Rezoning Transportation Analysis

Petition Number: 2019-028

Revision Log:

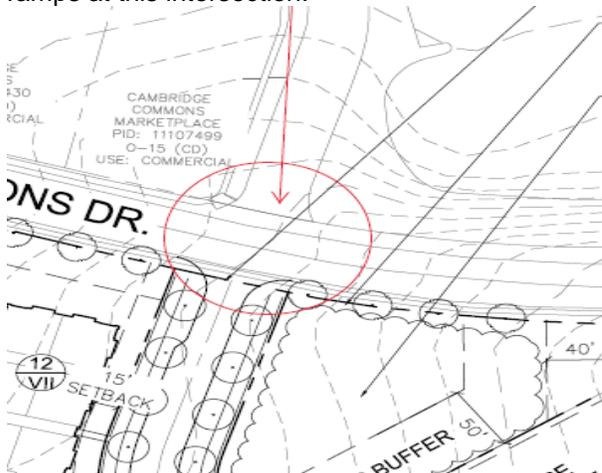
- ~~1. **Traffic Study Revised Site Plan (06-10-19)** The traffic study has been completed, and reviewed by both CDOT and NCDOT.~~
- ~~2. The petitioner should revise the site plan and conditional note(s) to commit to an 8' planting strip and a 12' Multi-Use Path.~~
- ~~3. The petitioner should revise the site plan and conditional note(s) to commit to installing a pedestrian refuge on Cambridge Commons Drive to connect to shopping center in the general area shown below. **Comment Rescinded**~~
